**PLANNED UNIT DEVELOPMENT  
& SUBDIVISION STAFF REPORT****Date: June 2, 2016****DEVELOPMENT NAME**

Azalea Oaks Center Subdivision

Planned Unit Development Approval to allow multiple buildings on a single building site and Subdivision Approval to create 2 legal lots of record from several existing lots.

# SITE PLAN

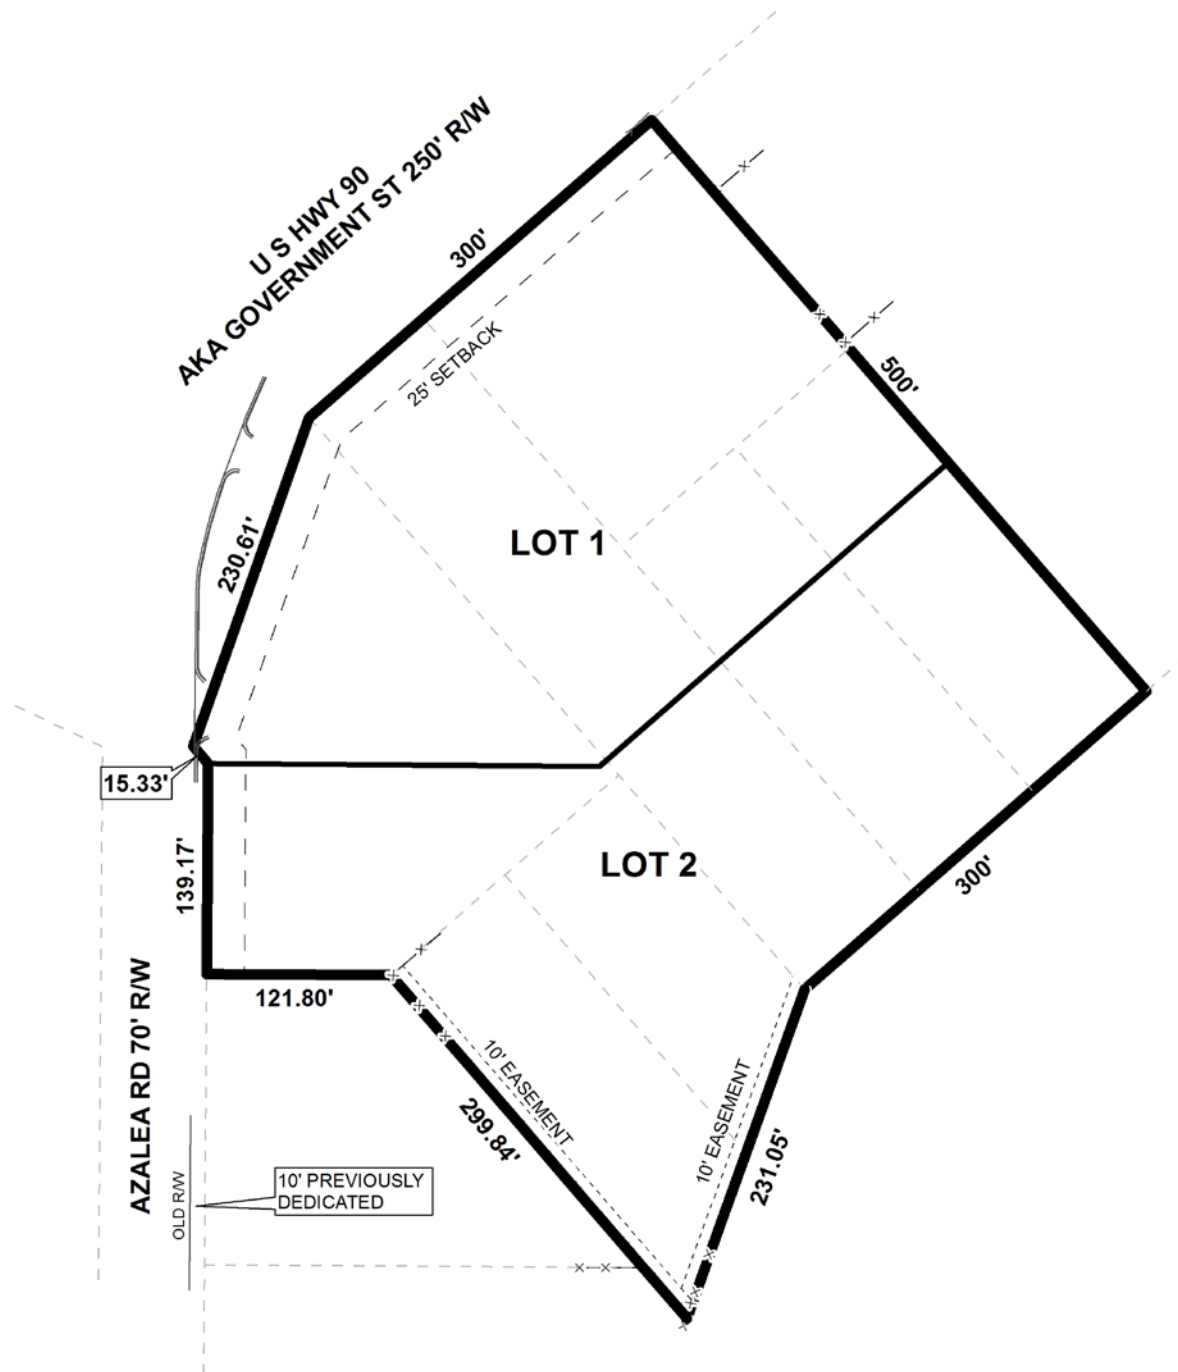
All proposed parking areas for the proposed Lot 1 also appear to be compliant in terms of travel aisle width, parking stall dimensions, and number of spaces (55); however, it should be pointed out that the proposed parking spaces around the proposed commercial building do not appear to contain any bumper stops or curbing. Any revised site plan or building plan should comply with Section 64-6. of the Zoning Ordinance, in addition to design compliance with the accessibility requirements of the applicable building code section at the time of permitting.

The site plan provides landscaping information and illustrates tree plantings, however Lot 1 appears to be short of the required number of frontage trees. Staff calculates that 8 frontage trees will be required along the Azalea Road frontage of Lot 1, 10 frontage trees along the Government Boulevard frontage, and 13 overstory and understory trees for the remaining parking and perimeter requirements, for a total of 31 trees for the Lot 1 site, of which 23 must be overstory trees (*the existing live oak that will be retained on the Lot 1 site will provide 6 credits that can be applied to satisfy a portion of the perimeter and parking tree requirements, thus only 25 new trees will be required*). Frontage trees must typically be placed according to the respective frontage, thus the proposed location of the underground fuel tanks along the Azalea Road right-of-way may require reconsideration in order to accommodate the required frontage trees.

The site plan depicts an 800 square foot restaurant within the convenience store. There appears to be an associated drive-thru lane for the restaurant, but no depiction or note of an order station or pick up window. The site plan should be revised to reflect full compliance with the drive-thru requirements of Section 64-4.F. of the Zoning Ordinance.

There are several corrections necessary regarding the tables on the site plan. Under tree requirements there should be 18 frontage heritage trees required. There should be 55 parking spaces listed instead of 49 under parking area. There should be 3 total parking understory trees under total tree requirements and there are 26 vacuum island stalls shown instead of the 25 listed under parking requirements. The site plan and tables should be revised to accurately reflect the site.

*In addition to the tree planting and landscaping changes, the site plan has been revised since the previous meeting depicting some minor changes to the site. The size of the tunnel for the car wash has increased from 2,880 square feet to 4,420 square feet; thus causing the drive aisle to the car wash tunnel to be altered from the original design.*

*The underground storage tank location has been relocated from within the frontage area of the site to a closer proximity to the fuel dispensers.*

*The drive-through for the proposed restaurant now indicates notes regarding the menu board and pickup window along with what appears to be sufficient queuing spaces.*

*It should be pointed out the preliminary plat states the total size of Lot 1 is 122,100 square feet while the site plan states that the total lot size of Lot 1 is 121,882. The Final Plat and/ or the site plan should be revised to reflect the same number of total square footage for Lot 1.*

- 1) Revision of the labeling of the lot size in square feet and acres on the Final Plat or the site plan to reflect the same number of total square footage for Lot 1;*

- 4) Retention of the site plan to illustrate curbing and/or bumper stops for all proposed parking spaces;*
- 5) Retention of the site plan to depict full compliance with the drive-thru requirements of Section 64-4.F. of the Zoning Ordinance;*
